ALERT SERVICE BULLETIN

REVISION NOTICE

TO: **All Owners/Operators of Bell 412 Helicopters**

SUBJECT: **REVISION "A" TO ALERT SERVICE BULLETIN 412-99-97: (HIGH LANDING GEAR AFT CROSSTUBE ASSEMBLY P/N 412-050-011-ALL AND P/N 412-050-045-105-/107/107A, ASSIGNMENT OF A RETIREMENT LIFE)**

FIGURE 1

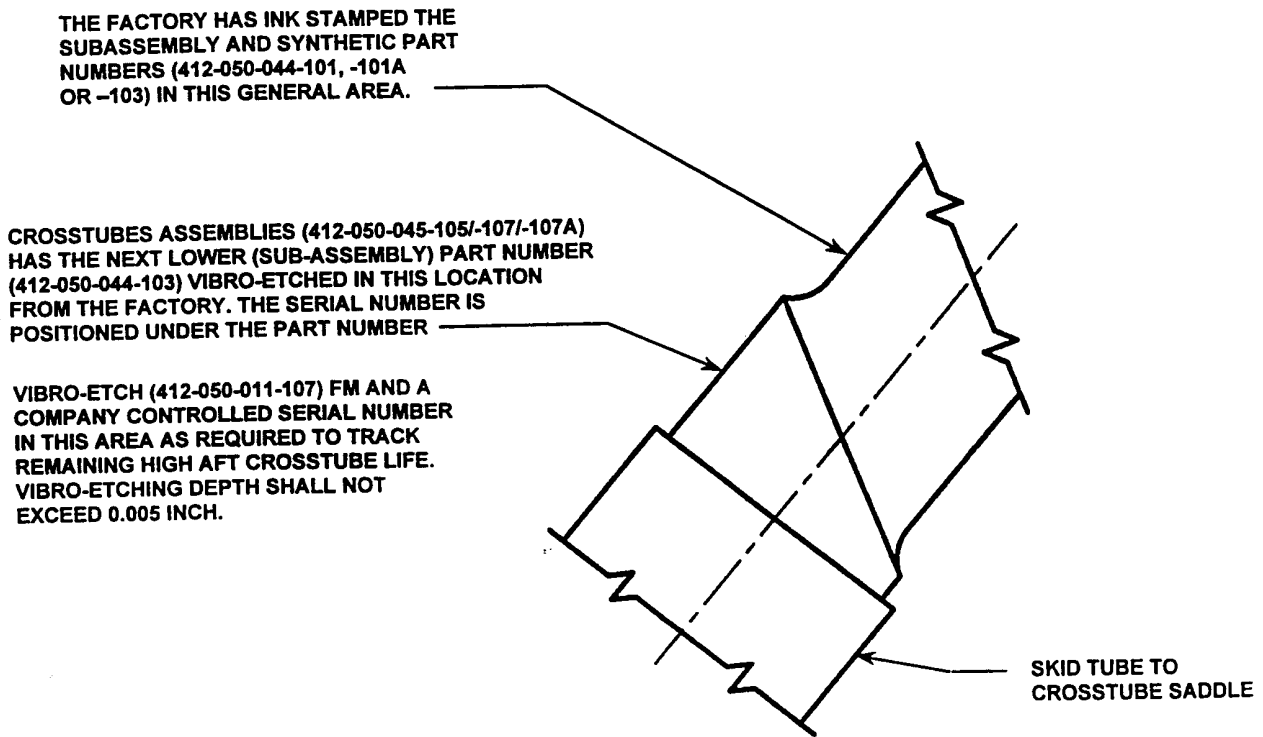
Only the new generation high aft crosstubes assemblies (P/N 412-050-045-107) have a factory generated part number and serial number located on the crosstube adjacent to the skid tube saddle per Figure 1. The part number vibro-etched in the crosstube is the next lower assembly P/N 412-050-044-103.

4. Place the calculated takeoff/landing information on the Historical Record form and track the applicable life as per the compliance section of the bulletin.
5. Bell Helicopter Textron crosstubes not displaying a visible part number/serial number per figure 1 will be required to be identified as P/N 412-050-011-107FM. Vibro-etch the part number on the crosstube adjacent to the skid tube saddle per figure 1.

6. Vibro-etch a company-controlled serial number below the part-number on the crosstube adjacent to the skid tube saddle per figure 1.

FIGURE 2

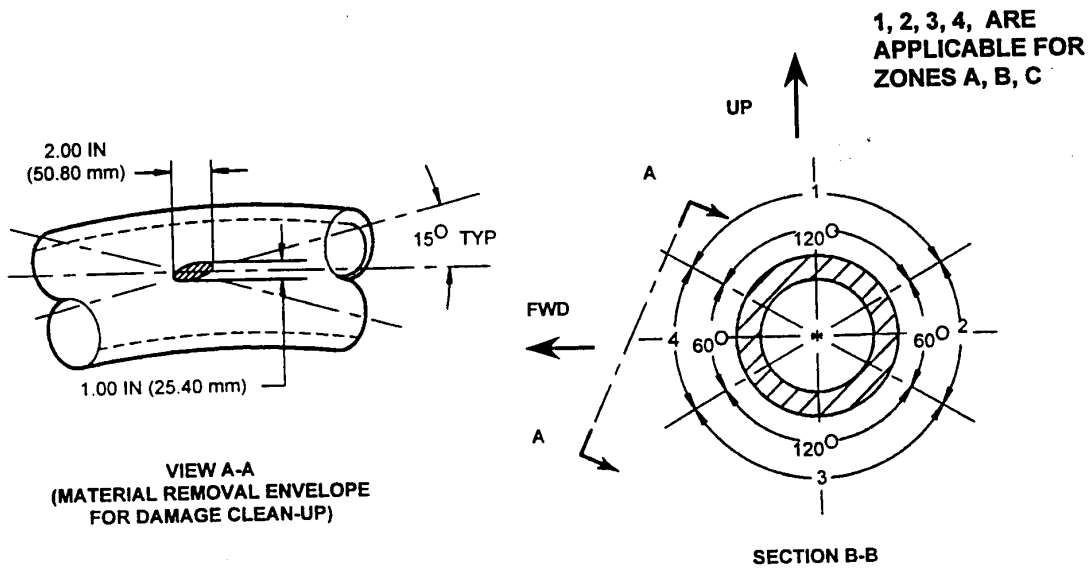
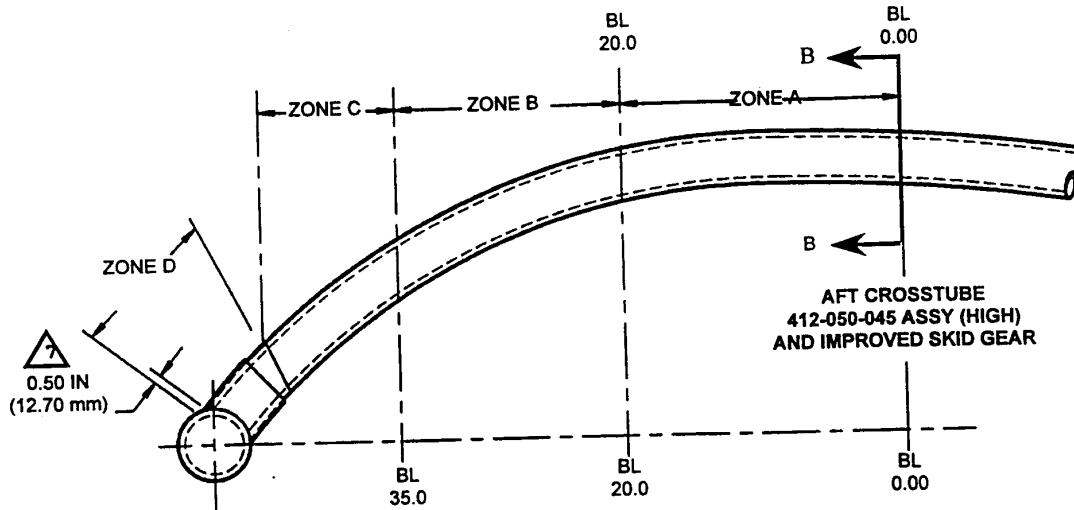
New aft crosstubes, P/N 412-050-044-103, must also meet new damage limits per Table 1 and Figures 2 and 3.

Allowable depth of repair is 0.050 inch (1.27 mm) for bottom 0.50 inch (12.7 mm) of area as indicated except within 0.315 inch (8.00 mm) radius of center of any fastener hole. Otherwise, limits for Zone D are as shown in Table 1.

0.050 in. (12.7 mm) maximum damage allowed on first 0.50 inch (12.7 mm) of crosstube except as indicated by note

Maximum allowable damage in shaded area is determined in zone D inspection limits.

TABLE 1	
MAXIMUM ALLOWABLE CLEAN-UP DEPTH	
ZONE 	AFT CROSSTUBE INCHES (MM)
A1	0.005 (0.127)
A2	0.015 (0.381)
A3	0.005 (0.127)
A4	0.015 (*0.381)
B1	0.005 (0.127)
B2	0.015 (0.381)
B3	0.005 (0.127)
B4	0.015 (0.381)
C1	0.012 (0.305)
C2	0.012 (0.305)
C3	0.005 (0.127)
C4	0.012 (0.35)
D 	0.038 (0.965)
